South Texas Project Electric Generating Station P.O. Box 289 Wadsworth, Texas 77483

November 4, 2003 NOC-AE-03001584 10CFR50.90

South Texas Project Units 1 and 2 Docket Nos. STN 50-498, STN 50-499 Proposed Change to Technical Specification 3/4.3.3.5 for Remote Shutdown System

STP Nuclear Operating Company (STPNOC) submits the attached proposed amendment to South Texas Project Operating Licenses, NPF-76 and NPF-80. This license amendment request proposes revising Technical Specification 3/4.3.3.5 for the Remote Shutdown System to be consistent with the requirements of NUREG-1431.

TABLE 3.3-9 (Continued)

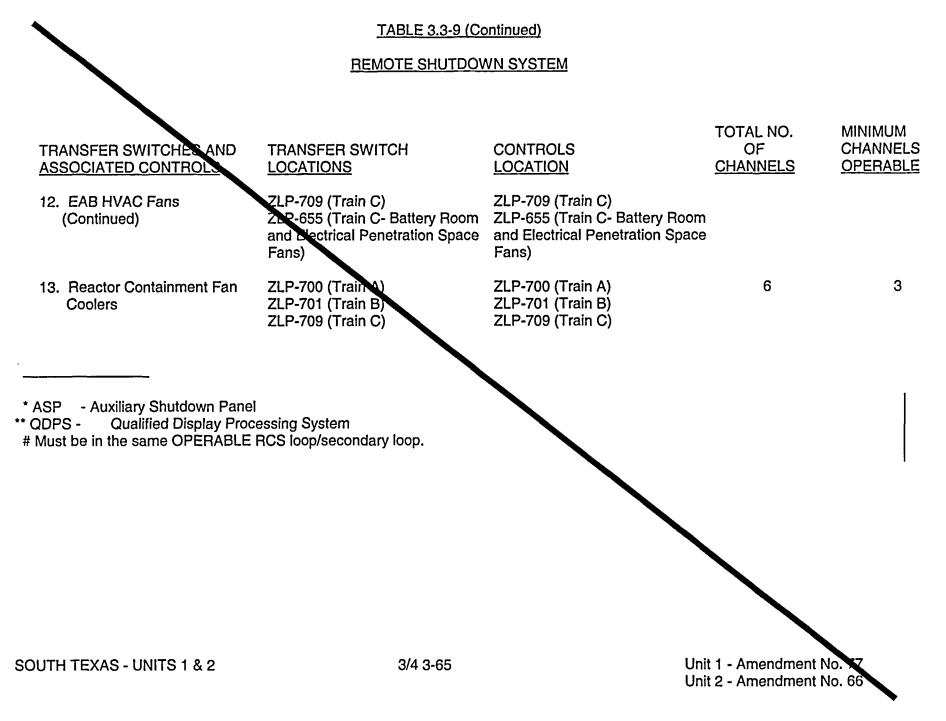
- 5. Re-letter current TS 3.3.5 ACTION c. as ACTION b. The statement that TS 3.0.4 is not applicable is consistent with NUREG-1431.
- 6. Delete Tables 3.3-9 and 4.3-6 and relocate the list of required Remote Shutdown System equipment to the Bases. This is consistent with NUREG-1431.

5.	Re-letter current TS 3.3.3.5 ACTION c. as ACTION b.	Administrative change
6.	Delete Tables 3.3-9 and 4.3-6 and relocate the list of required Remote Shutdown System equipment to the Bases.	Same as Item 1
